APPENDIX 6. GROUNDWATER, SURFACE WATER AND PFAS

Cabbage Tree Road Sand Quarry - (EPBC 2016-7852)

Williamtown Contamination Water Working Group Comments on the EIS for the Cabbage Tree Road Sand Quarry Project

Williamtown Water Working Group Comments on the EIS for the Cabbage Tree Road Sand Quarry Project

Source: AECOM Australia Pty Ltd (2015) Sampling Analysis and Quality Plan, RAAF Williamtown Stage 2B Environmental Assessment (Draft), Figure 4

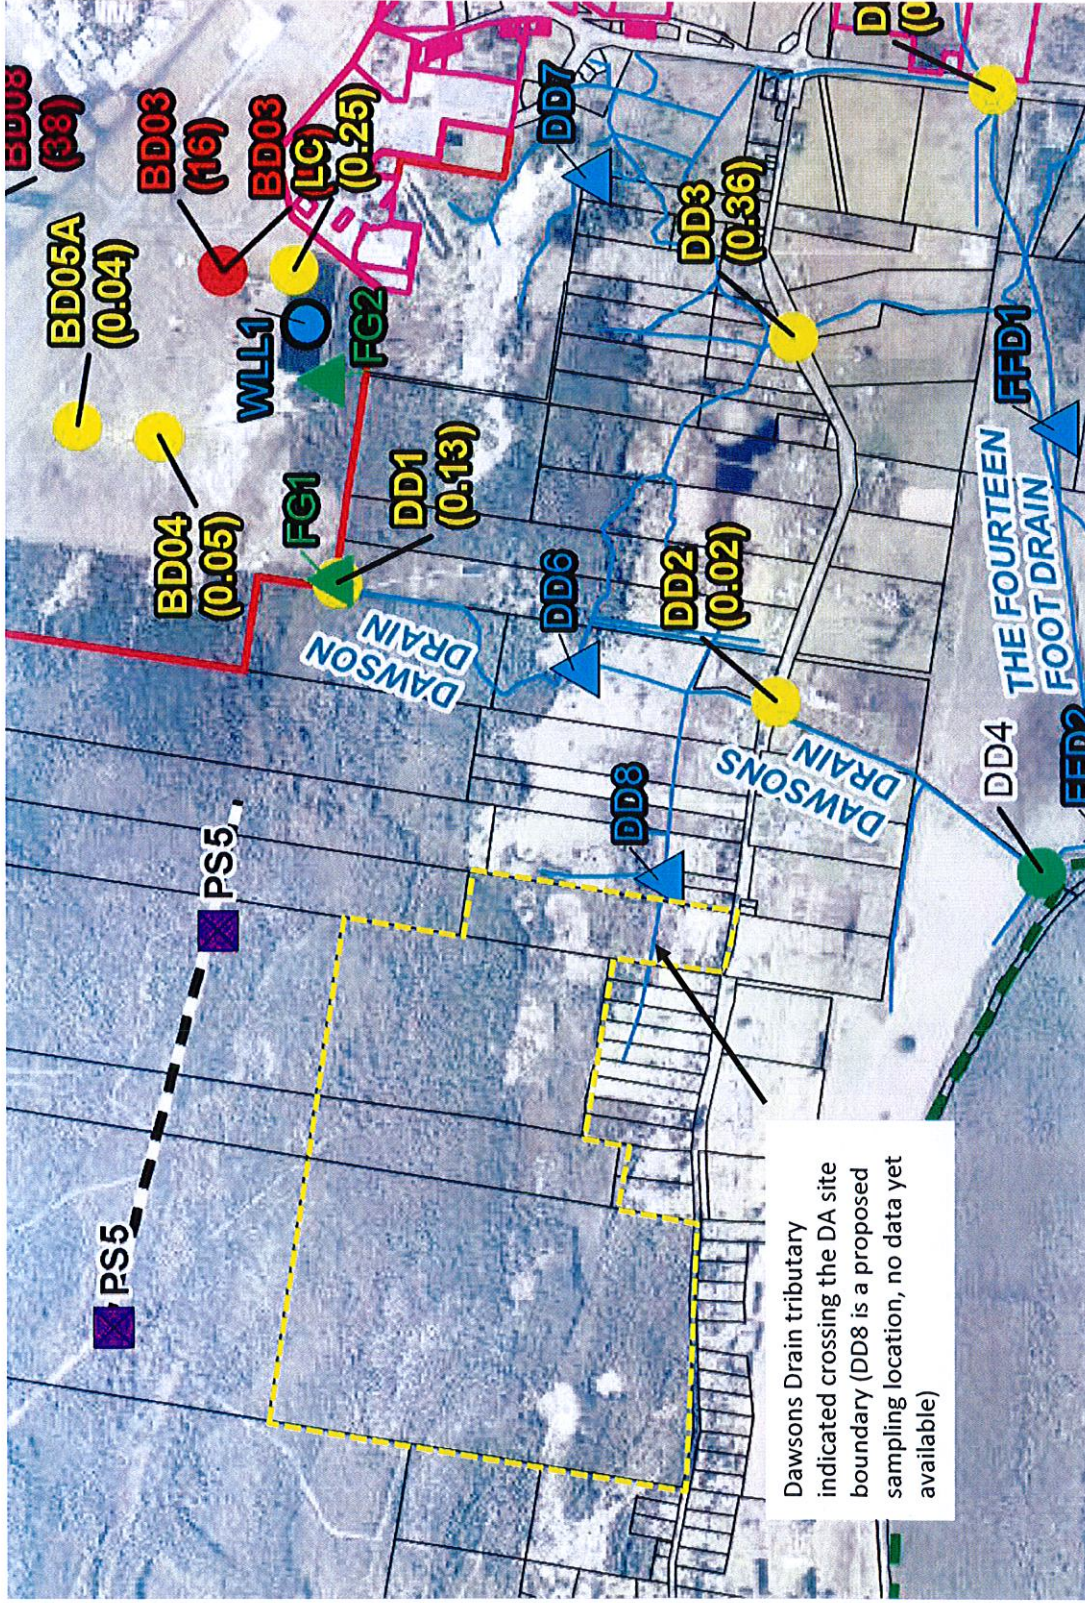
- The EIS indicates that there are no water courses on the site.
- The Sampling, analytical and Quality Plan (SAQP) for the Stage 2B environmental assessment of the Williamtown site (Fig 4, see attached) indicates a tributary of the Dawson Drain extending across a portion of the site, however this may be an ephemeral surface drain.
- PFOS was reported at 0.02 µg/L in Dawson Drain where it intersects Cabbage Tree Rd, which appears to be ~200 metres east of the sand mining site boundary.
- The SAQP included a proposed sampling location (DD8) right at the sand mine site boundary (see attached Figure), but no results have been noted by the WWG to date.

Source: URS Australia Pty Ltd (2015) Stage 2 Environmental Investigation, AFFF PFAS, RAAF Base Williamtown, Williamtown, NSW

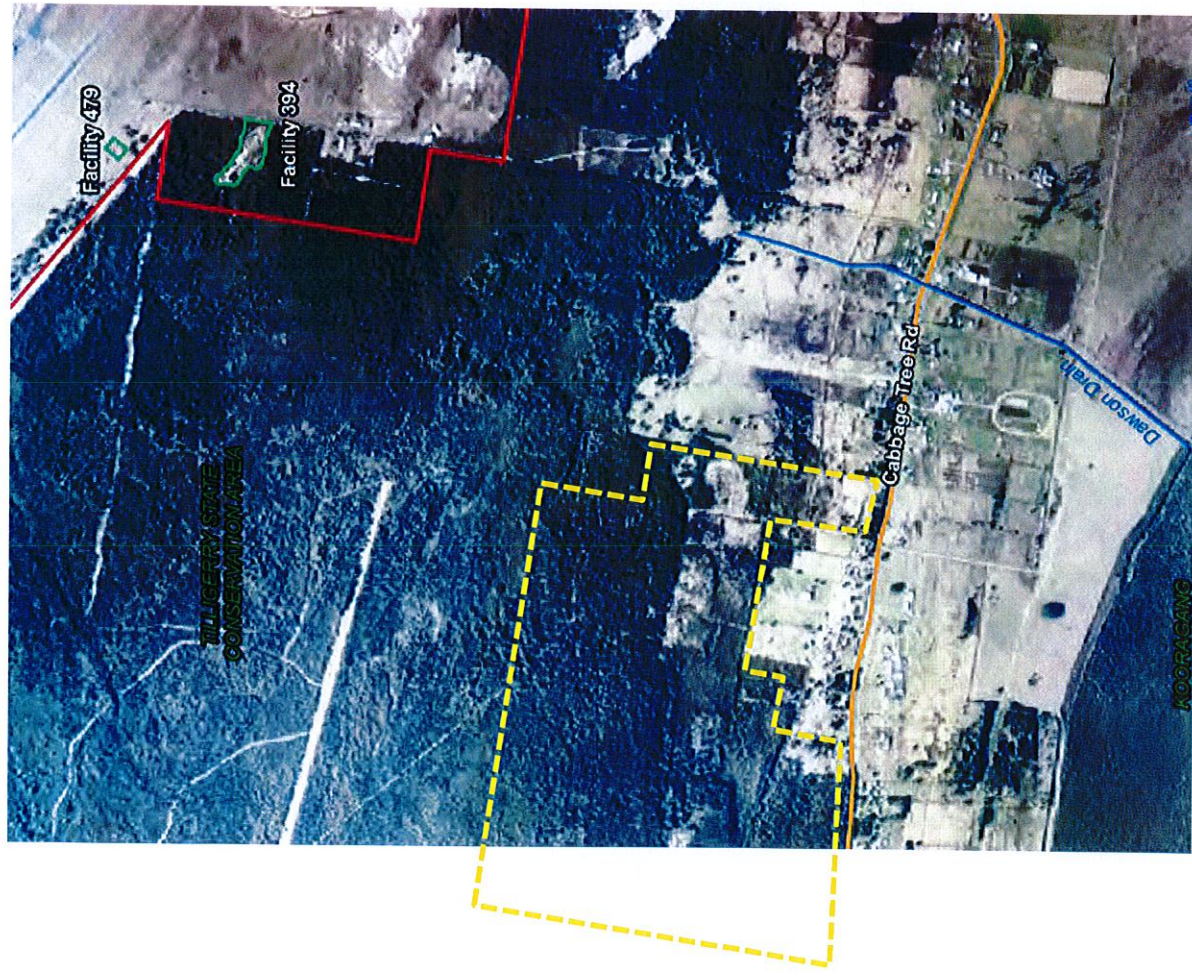
- The development proposal is to extract sand to within 1m of the historic high water level (i.e. the intention is not to intersect the water table)
- No groundwater extraction is proposed to supply any of the water requirements for the sand mining operation. They intend to rely on mains water for their needs (which, according to their process description, are small as they will not be washing sand on-site). Water use will be for amenities blocks on site and dust suppression.
- The site is to the south, and slightly west, of the Facility 479 and 374 PFAS source areas on the Williamtown RAAF Base (see attached Figure)

- Based on an inferred southward groundwater flow direction in this area, a plume issuing from the Facility 479 and 374 would likely pass close to, but to the east of, the sand mining boundary
- Nested monitoring wells MW107S/I/D are located approx. midway between the sand mining site and the Facility 479 and 374 source areas – presumably these wells were intended to attempt to define the western boundary of PFAS impacted groundwater. Results from URS (2015) indicate:
 - PFOS was not detected in all three wells
 - PFOA was detected at 0.01 µg/L in the intermediate well (11m depth), and not detected in the others
- Monitoring well MW124 (7.5 m depth) is located on to Cabbage Tree Rd, adjacent to the southern boundary of the sand mining site. Results from URS (2015) indicate:
 - PFOS was detected at 0.01 ug/L
 - No detection for PFOA
